VERIFICATION REPORT CEP CARBON EMISSIONS PARTNERS S.A.

VERIFICATION OF THE
REDUCTION OF METHANE LEAKS ON THE GAS
EQUIPMENT OF THE GAS DISTRIBUTION POINTS
AND ON THE GAS ARMATURE, FLANGED,
THREADED JOINTS OF THE GAS DISTRIBUTION
PIPELINES OF PJSC "ZAKARPATGAS"

SECOND PERIODIC
FOR THE PERIOD OF 01/01/2008 – 30/06/2012

REPORT No. UKRAINE-VER/0647/2012

Figure 1 Structure of the Working Team

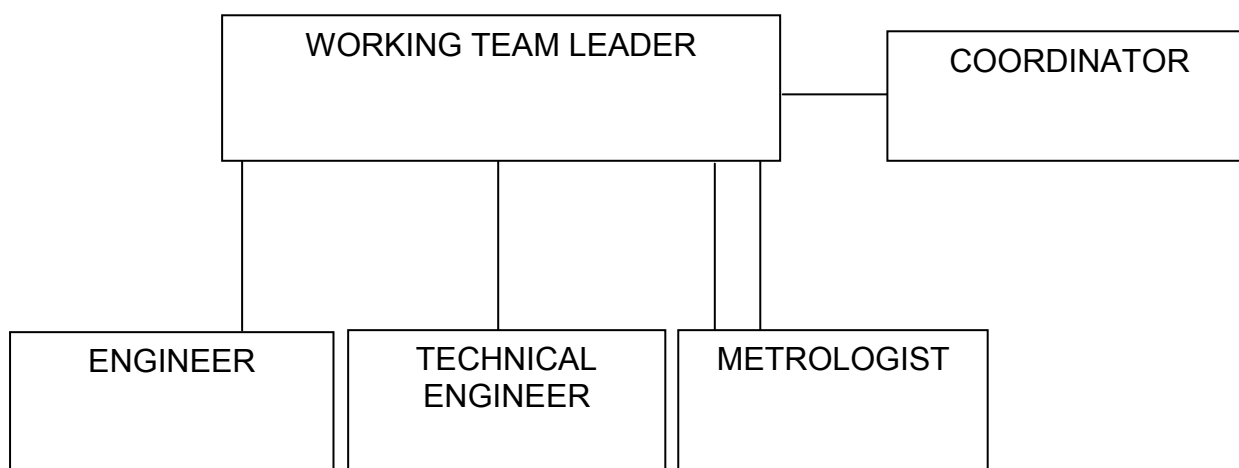
| <p>CAR 08. Please, provide the schematic illustration of the work of PJSC "Zakarpatsgas" Working Team in Section B.2.1.</p> | 101 (a) | <p>The scheme of Working Team work is provided. Refer to Section B.2.1. of the MR.</p> | <p>The issue is closed as relevant information was provided.</p> |
